**TOWNSHIP OF BERKELEY
ZONING BOARD OF ADJUSTMENT
REGULAR MEETING AGENDA
NOVEMBER 14, 2012
6:30 PM PUBLIC HEARING**

Re: **BOA #12-5406**
Applicant: Matthew Mazza
Application: Front Yard Setback on Paper Street
Block 596, Lots 45 thru 50
Fronting on Veterans Boulevard
Zone: R-150
EE & L Project No. 12B4533-7M06

RE: Mazza, Matthew
PLANNING REVIEW-#1
Application: Addition
Block 596 - Lots 45-50
Address: 371 Veterans Blvd
Zoning District: R-150 Residential Zone
Plan Title: Map of Survey Showing Proposed Addition
Prepared by: John P. Augustine, P.L.S., dated 9-8-04, revised 8/11/12
BOA#: 12-5406
Our File: 1506-Z-144

Re: **BOA # 12-5416**
Applicant: David Roman
Application: Use and Bulk Variances
Block 956, Lot 4
Fronting on: NJSH Route 9
Zone: HB & R-125
EE & L Project No. 12B4533-7R04

Aerial map for neighborhood comparison. Copied from Google earth and modified by RVV.

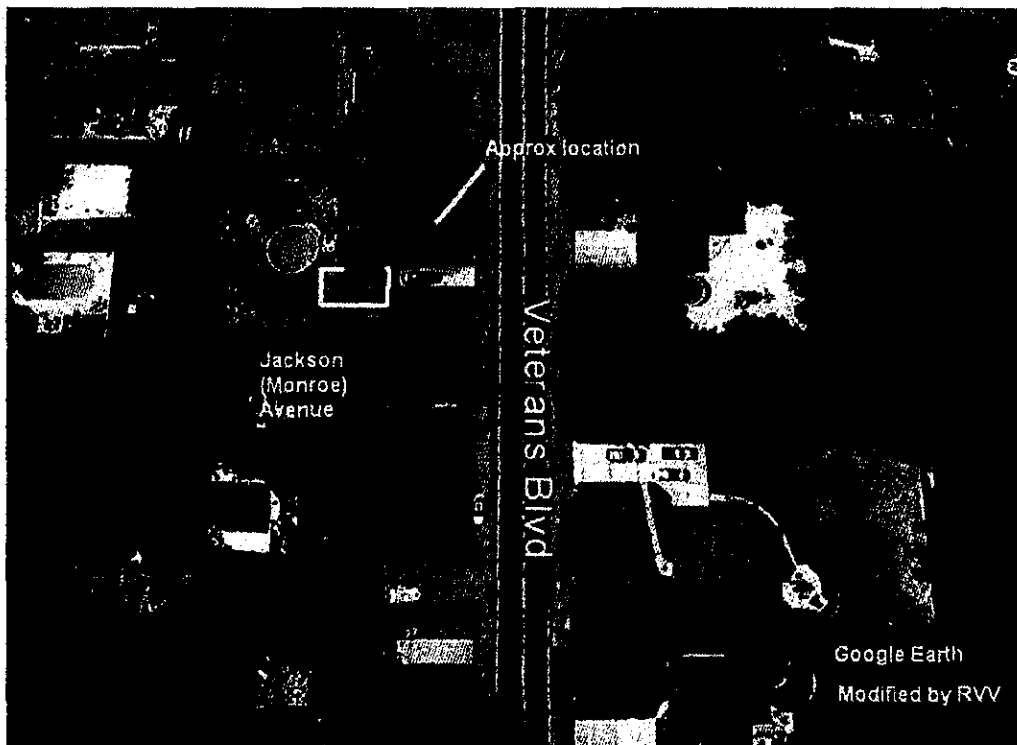
The existing 1 story single family dwelling is located on Veterans Boulevard and Jackson Avenue (AKA Monroe) between Elizabeth and Brick Avenues. Jackson Avenue is presently unimproved and wooded. The Applicant is required to meet the minimum front yard setback from both streets. The proposed one story 18' X 36' addition is located on the east side of the home, 23.7 feet from Jackson Street, whereas 35 feet is required. Therefore, the Applicant requires a variance for the setback from Jackson Street. The plans appear to indicate the construction of two new bedrooms and a bathroom. Testimony should be provided to the Board describing the proposed addition and the interior use of the space.
